2020-SMT-0026
10 CFR 50.30

SHINE Medical Technologies, LLC Application for an Operating License
Response to Environmental Requests for Additional Information

SHINE MEDICAL TECHNOLOGIES, LLC APPLICATION FOR AN OPERATING LICENSE RESPONSE TO ENVIRONMENTAL REQUESTS FOR ADDITIONAL INFORMATION

Figure 2. SHINE Process Overview

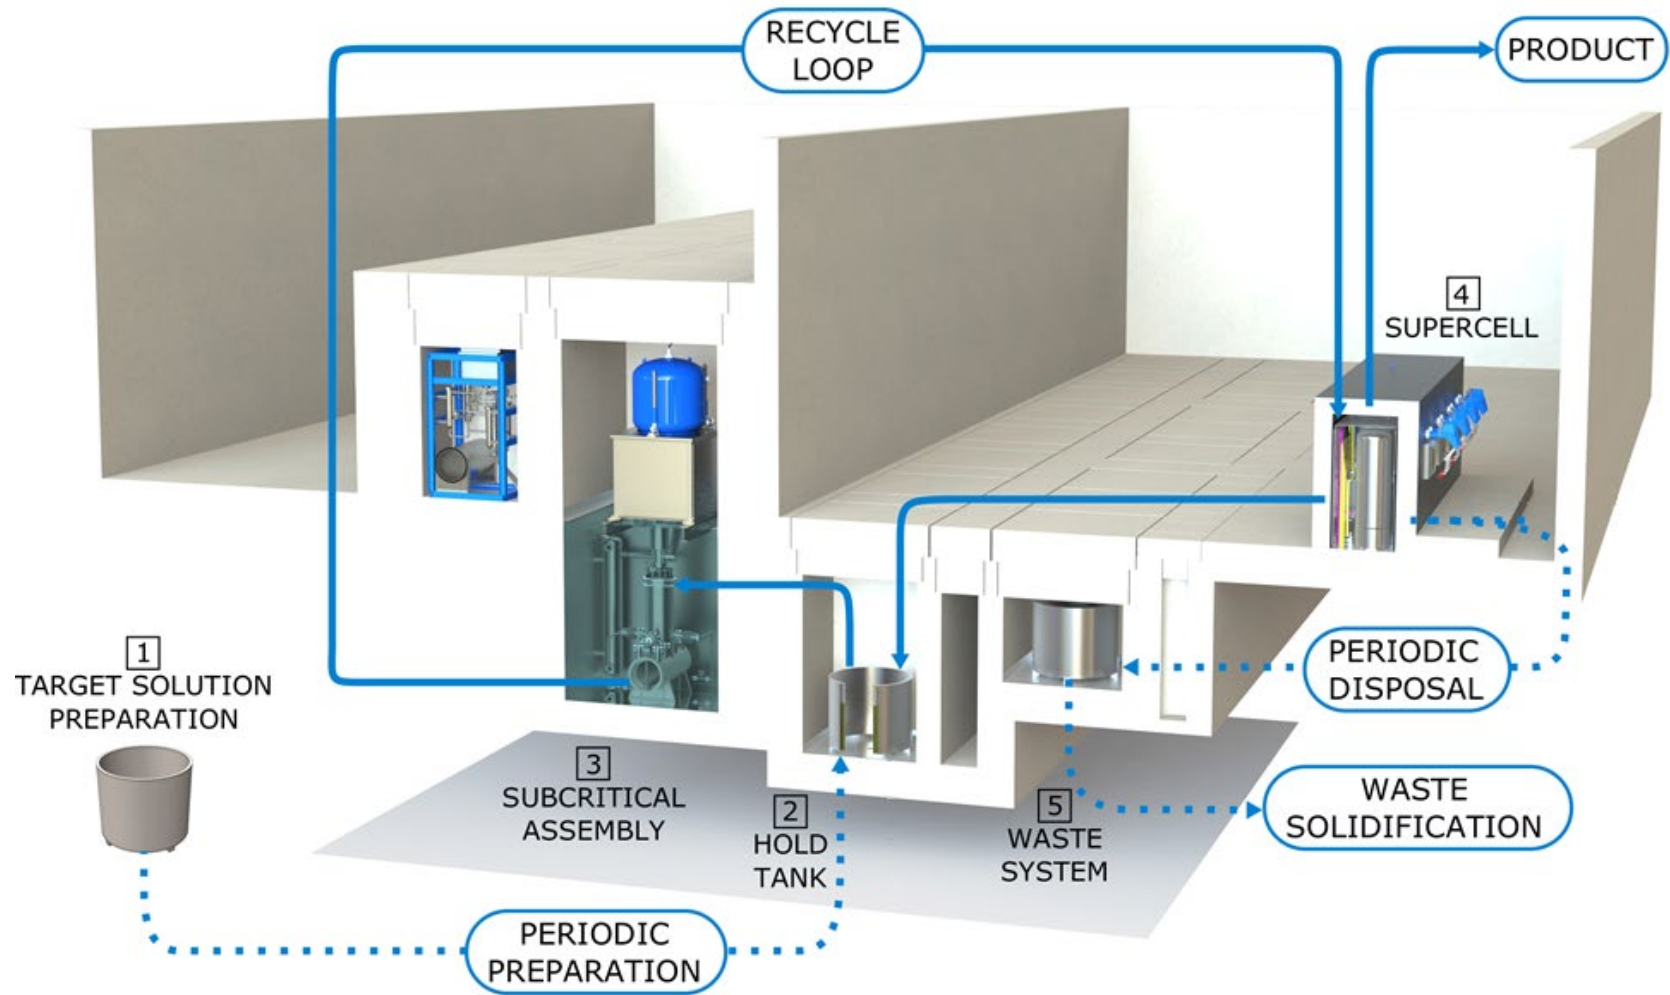
- a.) a conceptual view of the proposed SHINE facility and process (Overview Presentation Slide Nos. 3 and 10).
- b.) updated publicly available versions of conceptual graphics for the SHINE Device and a representative irradiation unit (Overview Presentation Slide No. 24).
- c.) a revised SHINE radioisotope production system flow diagram that describes the overall isotope production process (Overview Presentation Slide No. 12).

- a) A rendering of the proposed SHINE facility is provided in Figure 1. An overview of the SHINE process is provided in Figure 2.
- b) Renderings of the SHINE irradiation units are provided in Figure 3.
- c) A revised SHINE process flow diagram, describing the overall isotope production process, is provided in Figure 4.

Figure 5. Water Balance Diagram

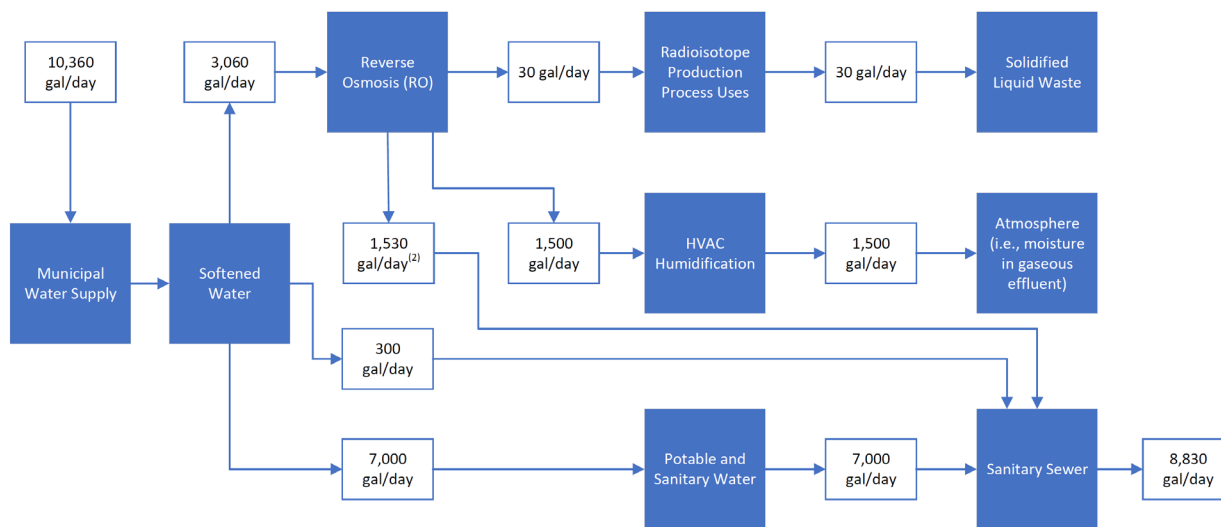
Provide a revised water flow/water balance diagram that shows the expected average daily makeup inputs and contributions from facility processes to the sanitary sewer, in accordance with the description in ER Section 2.3.

A revised water balance diagram showing the expected average daily makeup inputs and contributions from the SHINE facility to the sanitary sewer, atmosphere, and solidified liquid waste is provided in Figure 5.

Figure 6. Waste Treatment and Disposal Pathways Flow Diagram

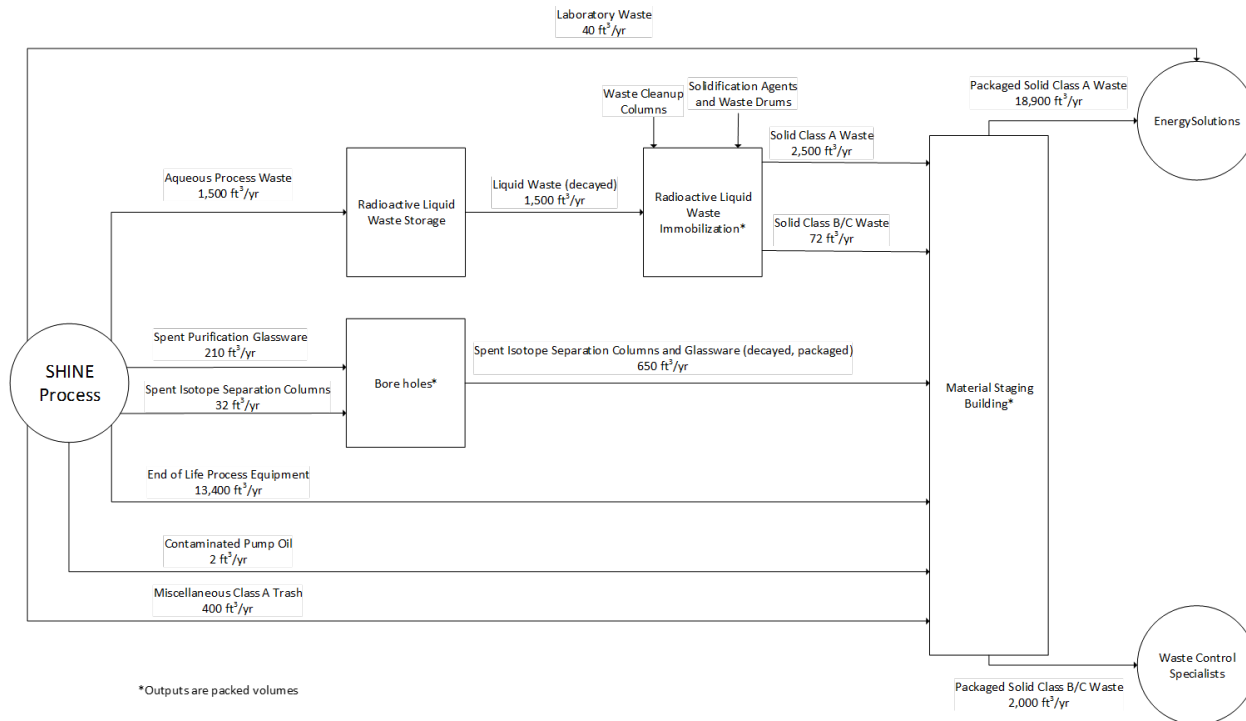
Provide process flow diagrams for the waste treatment and disposal pathways.

A process flow diagram for the waste treatment and disposal pathways is provided in Figure 6.
